SOLICITATION AMENDMENT 02

Title – Sujet Highway 4 Alder Removal - Pacific Rim National Park Reserve, BC		
Solicitation No. - N° de l'invitation : 5P420-18-0349/A	Amendment No. : 02	Date: December 27, 2018
GETS Reference No. N° de reference de SEAG : PW-18-00853292		
Solicitation Closes - L'invitation prend fin		
At - à : 02:00 PM On - le : January 3, 2019		Time Zone - Fuseau horaire : MST
F.O.B. - F.A.B. Plant - Usine : <input type="checkbox"/> Destination : <input checked="" type="checkbox"/> Other - Autre : <input type="checkbox"/>		
Address Inquiries to to - Adresser toutes questions à Adam Tan		
Telephone No. : (587) 436-5793	Fax No.: 1-866-246-6893	Email Address : adam.tan@canada.ca

Amendment No. (02): This amendment is raised to address bidder questions and to amend Annex “A” – Statement of Work for changes brought forward from the bidder questions:

INSERT: Appendix A: Site Plan Map:

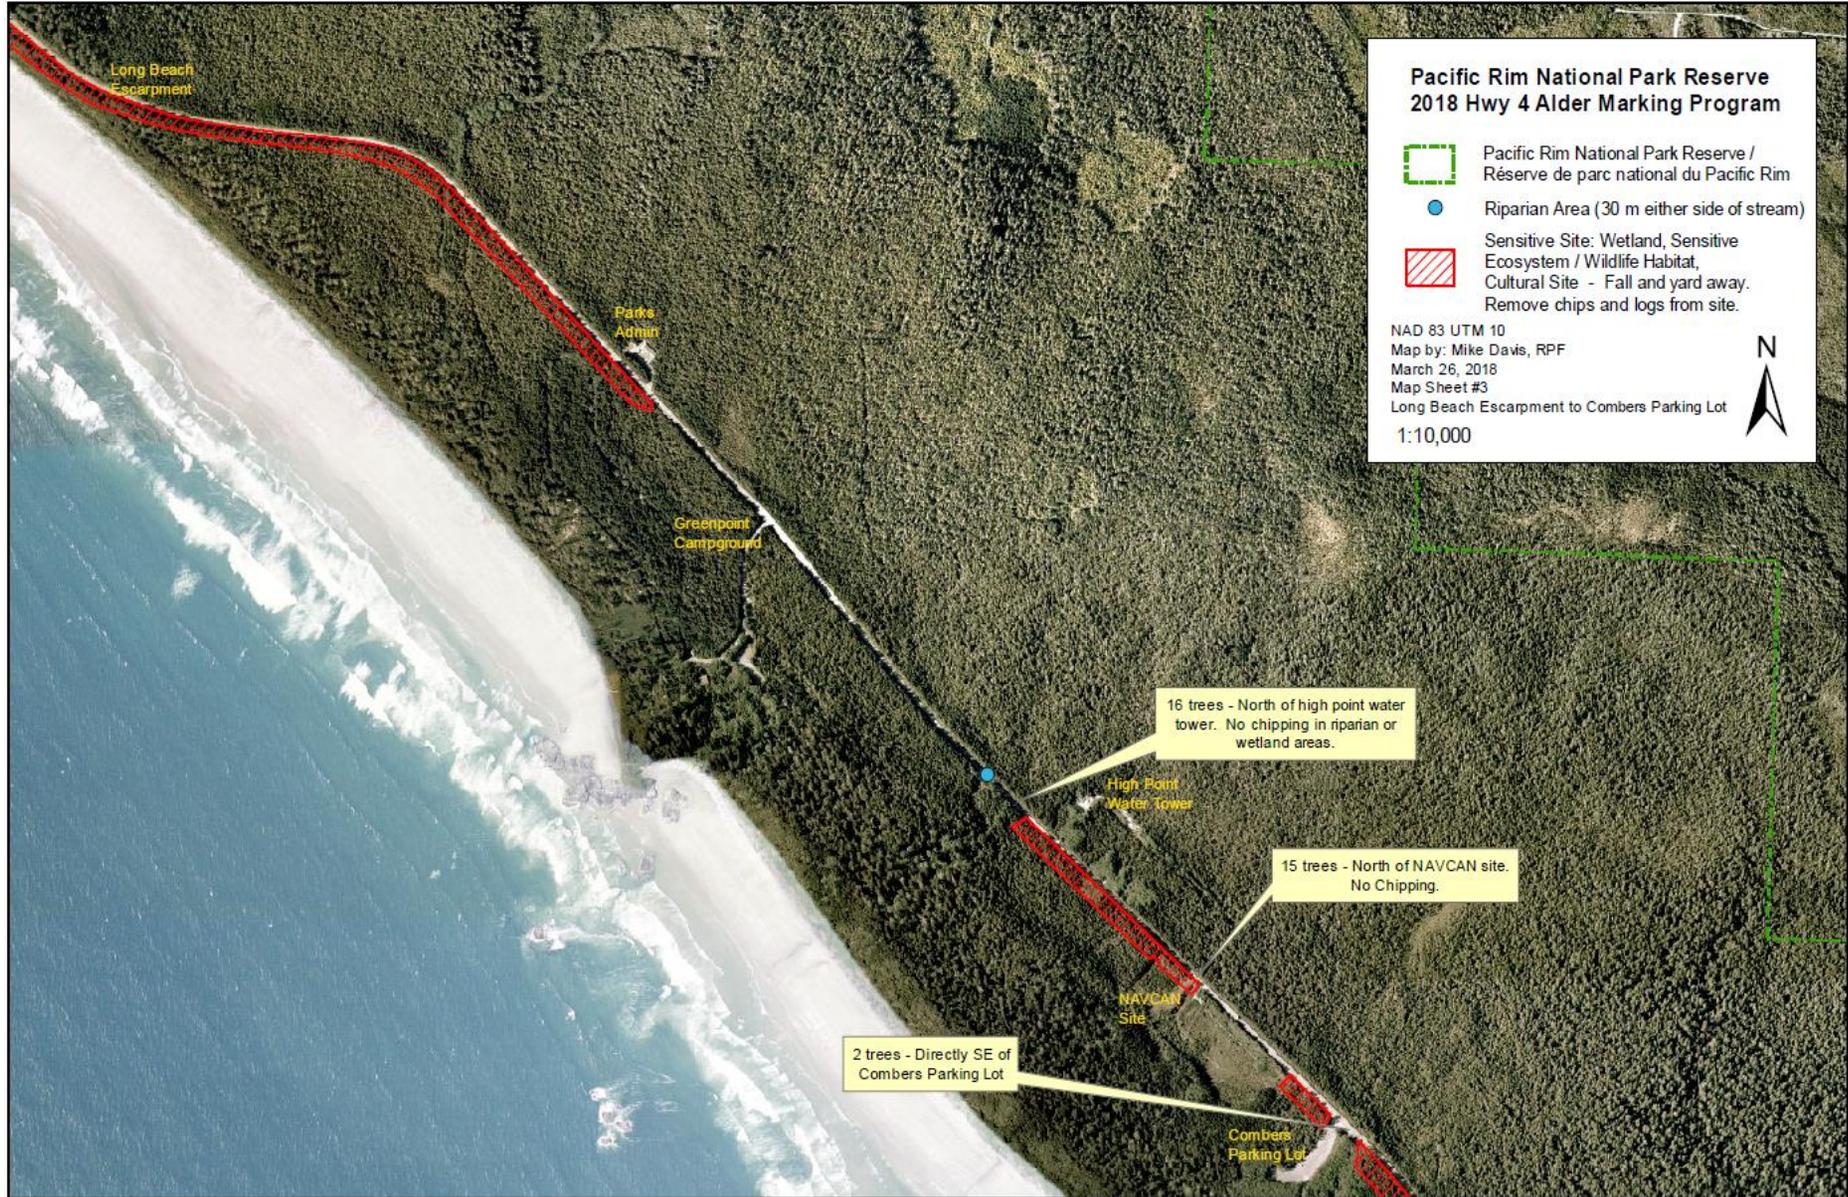
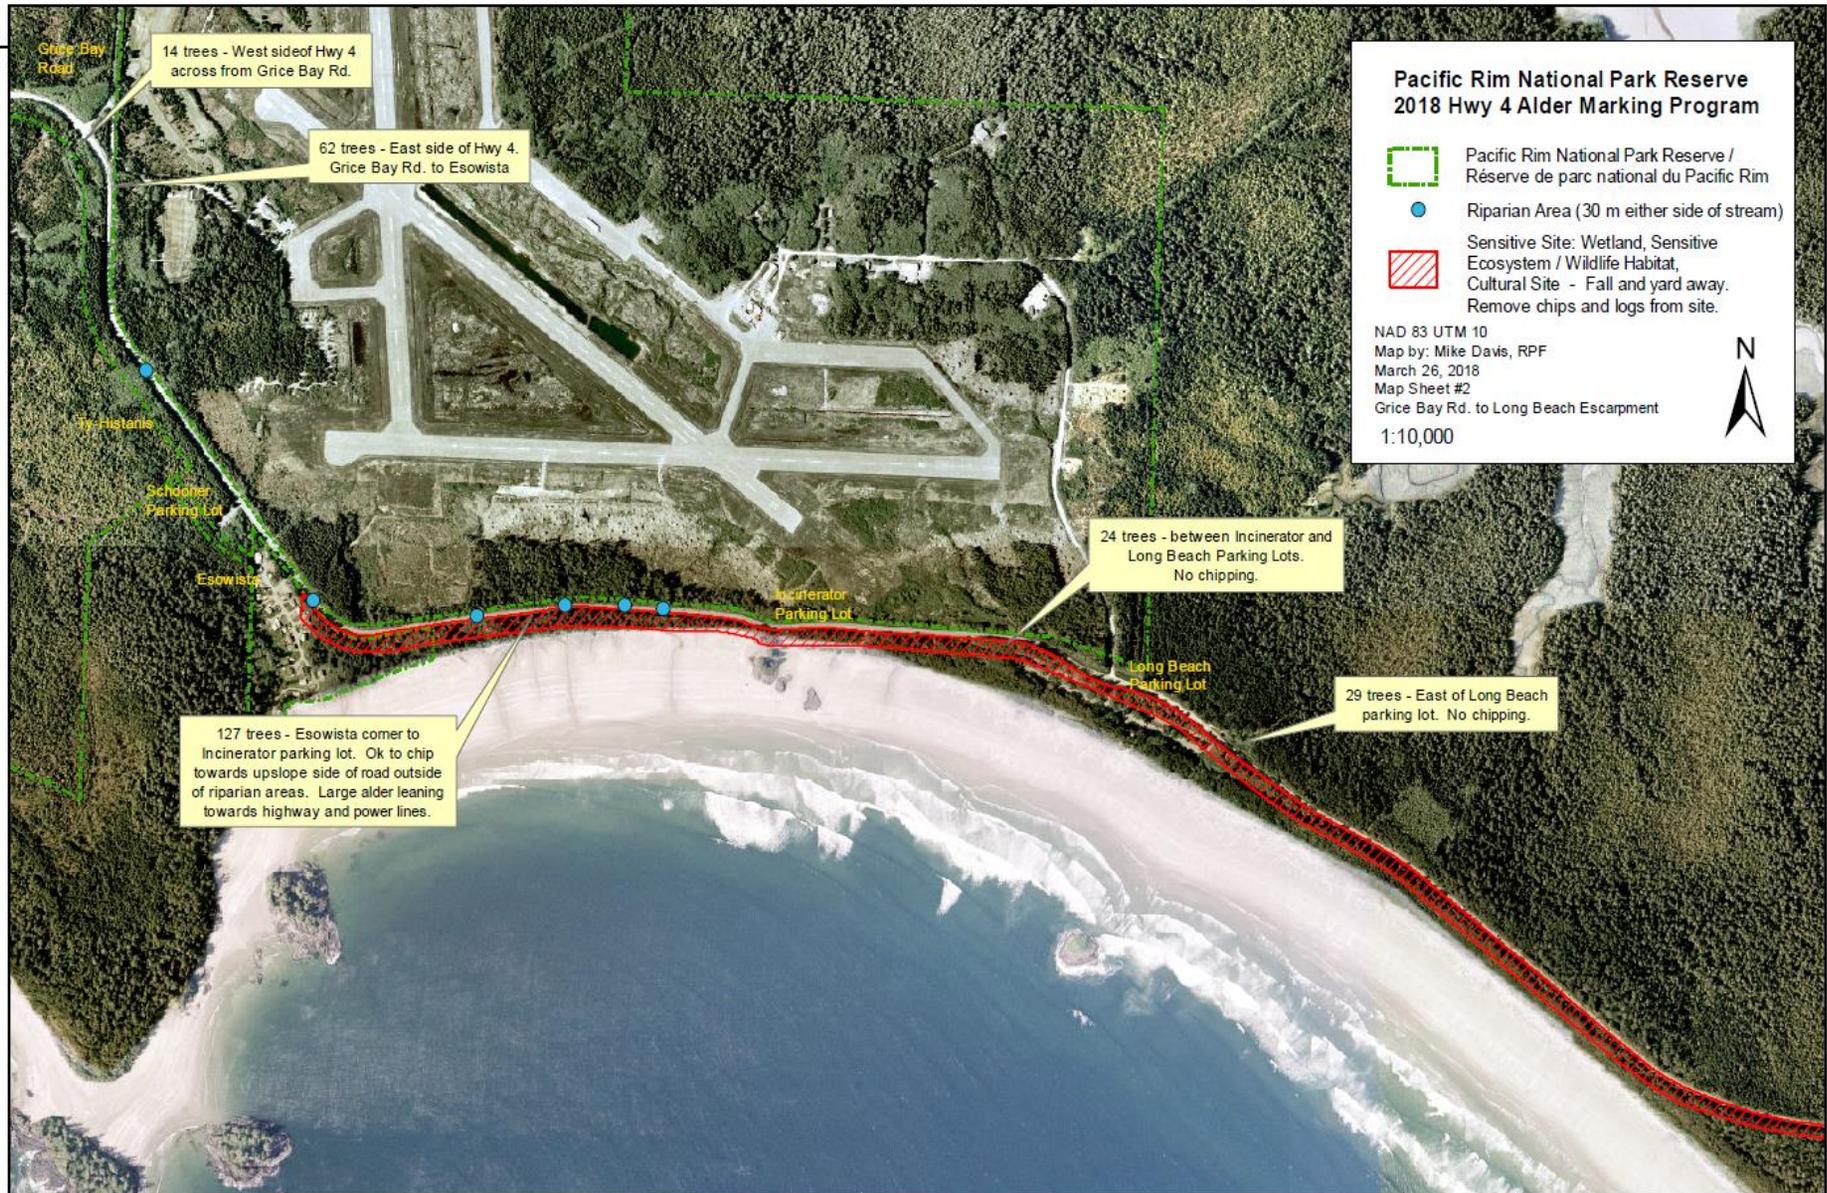
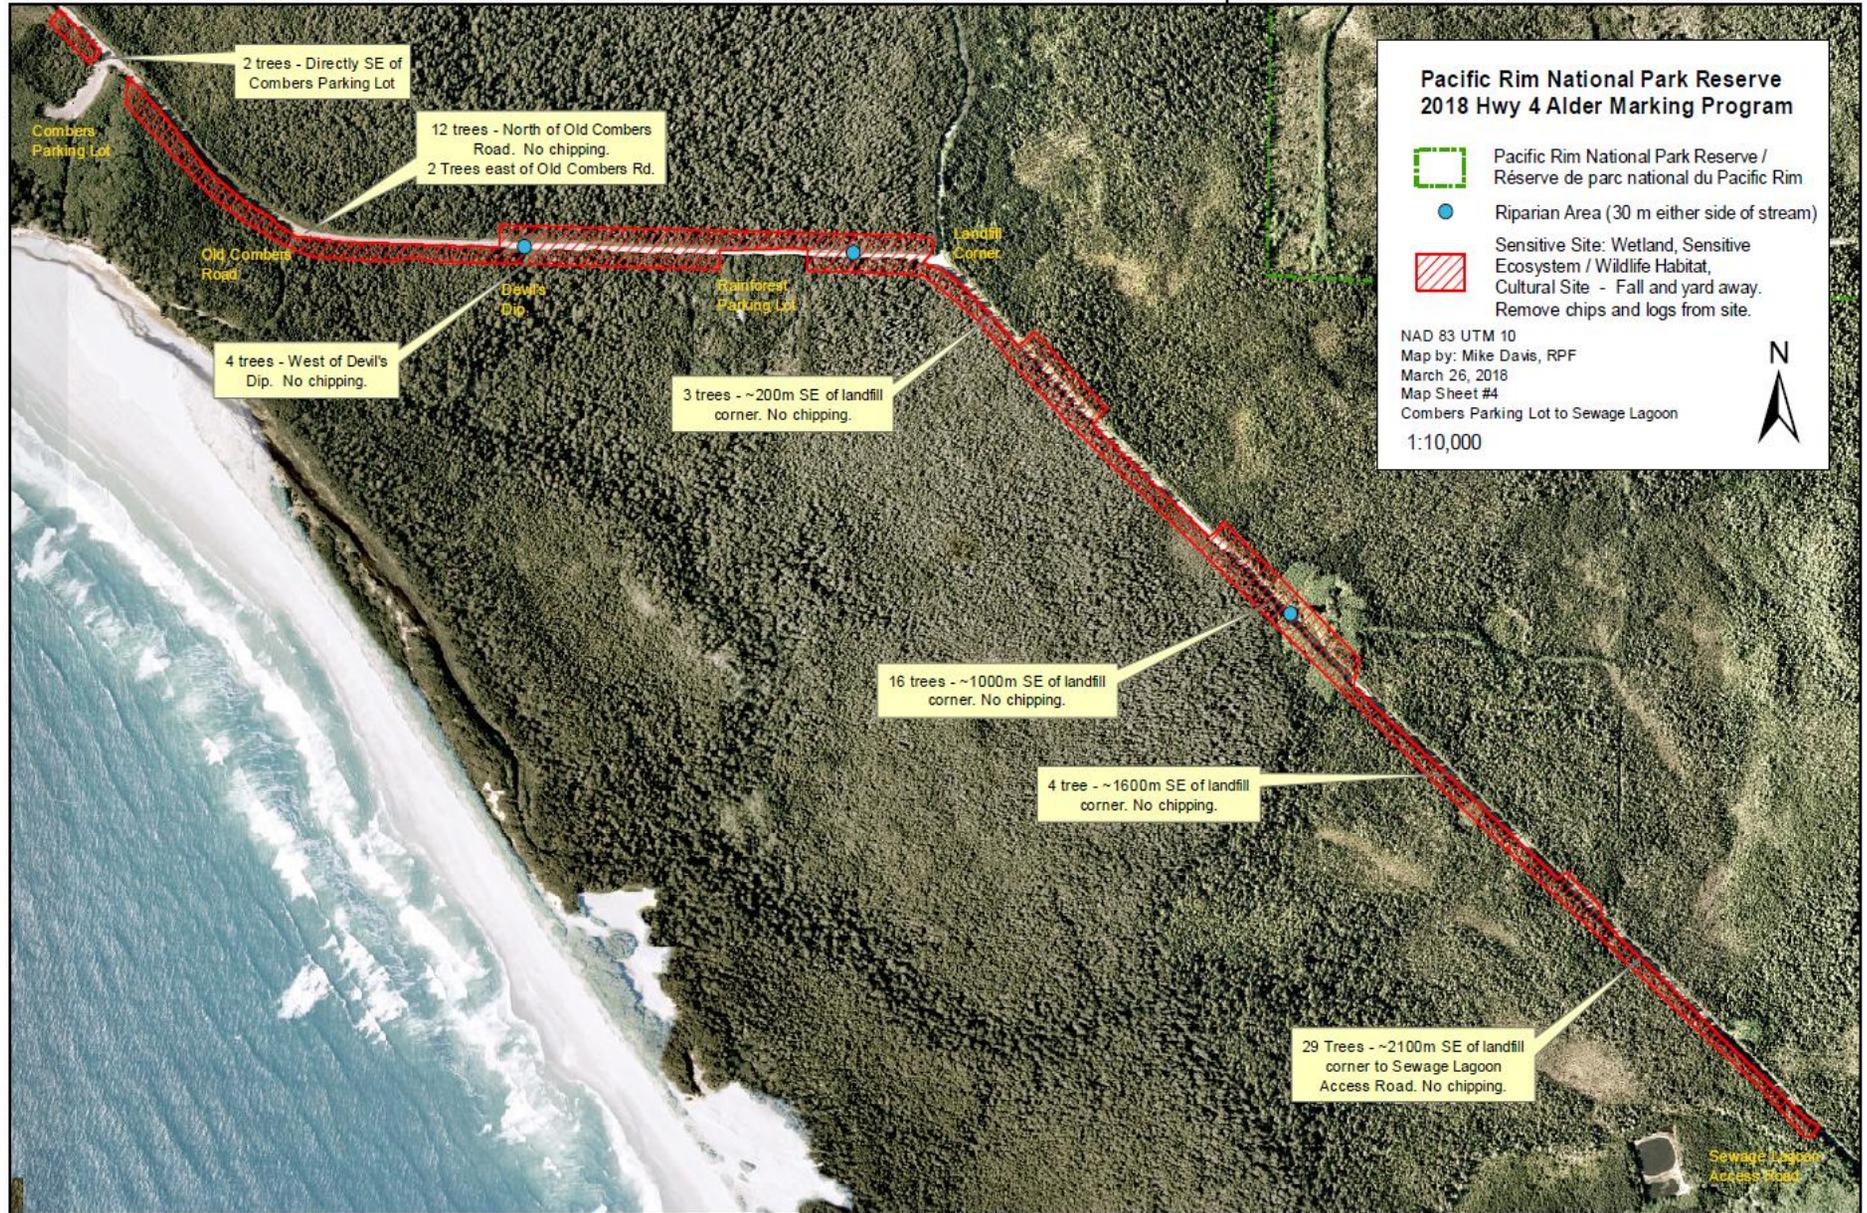
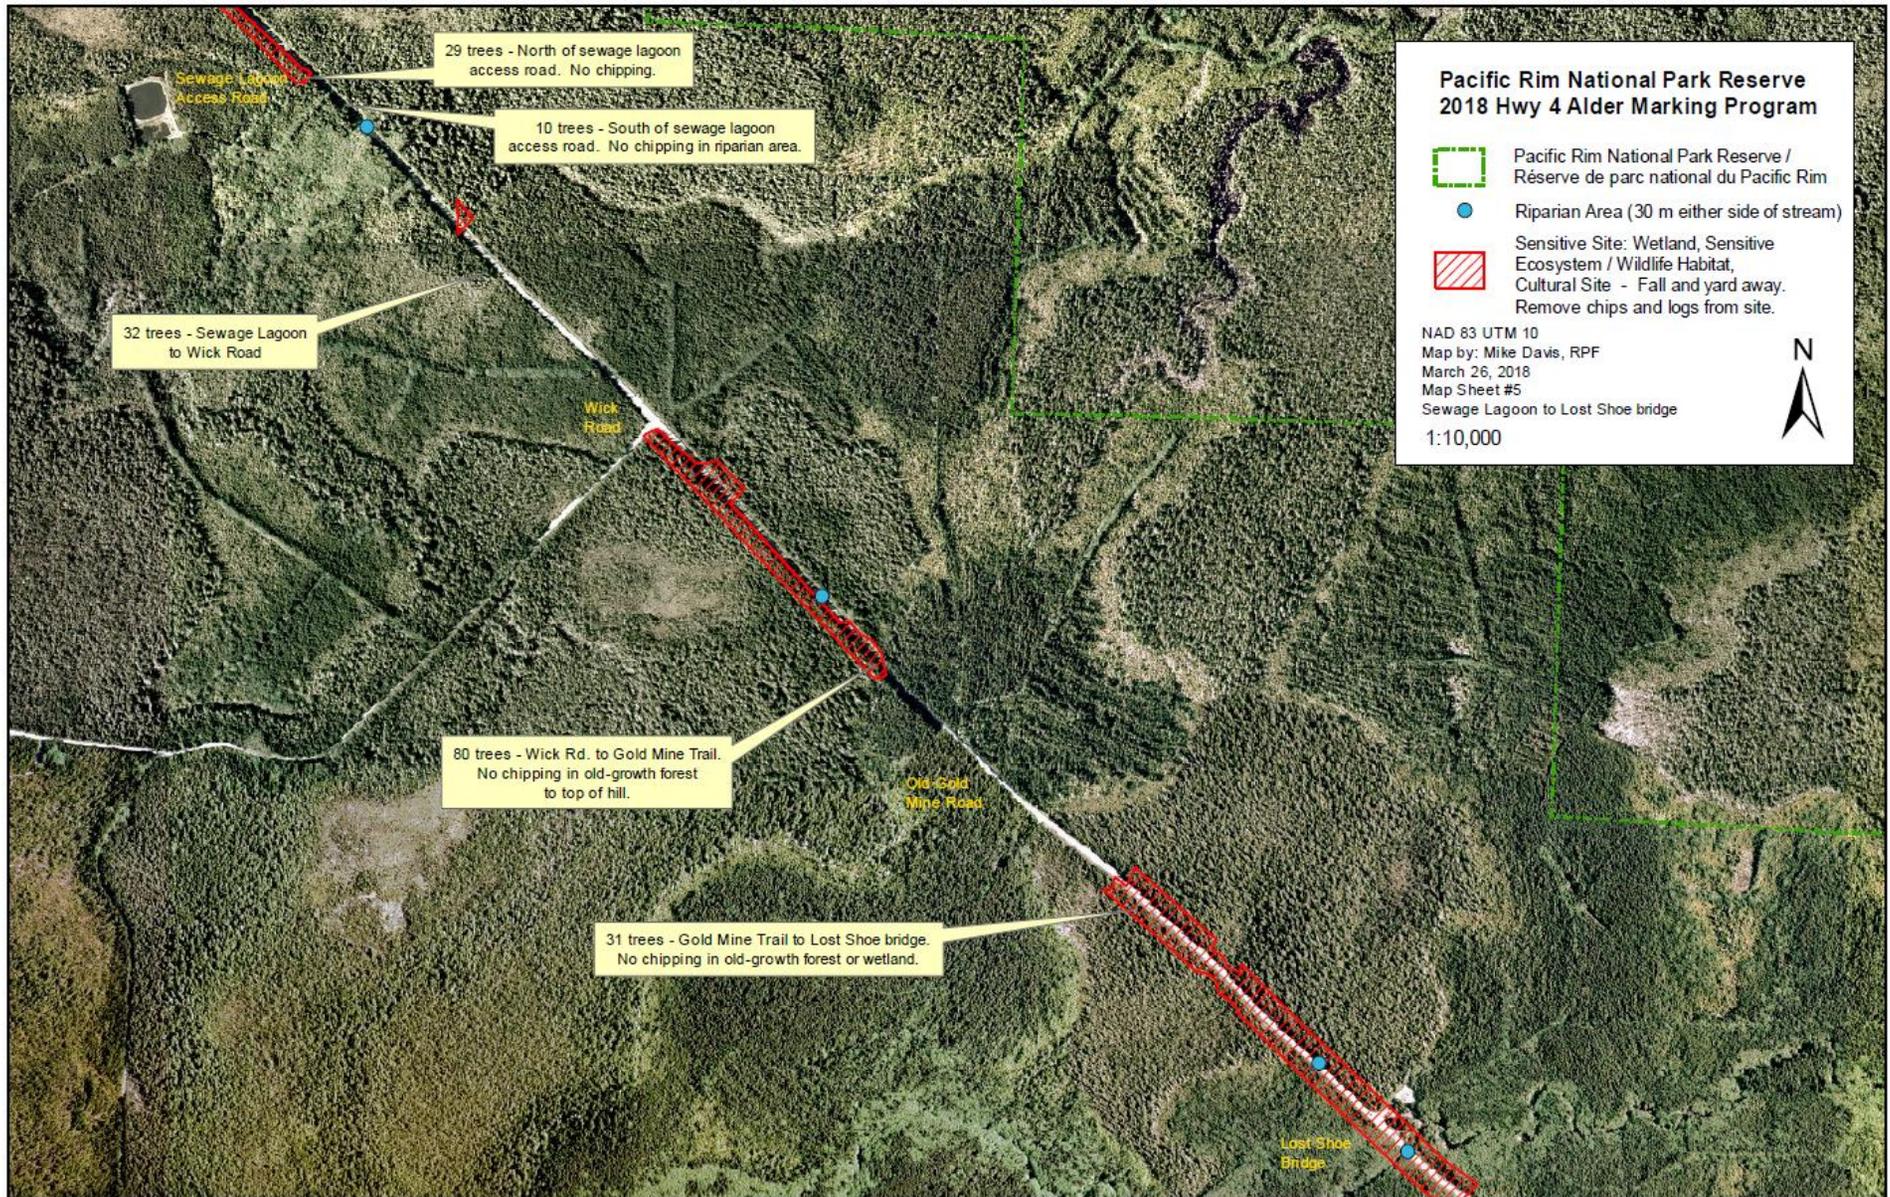
E) Amend Appendix A: Site Plan Map to include up to date maps

DELETE: Appendix A: Site Plan Map in its entirety and replace it with the following:

A2: No – all sites outlined in red on the maps are classified as sensitive areas. These make up the majority of the project area. Fall and yard away. Remove chips and logs from site.
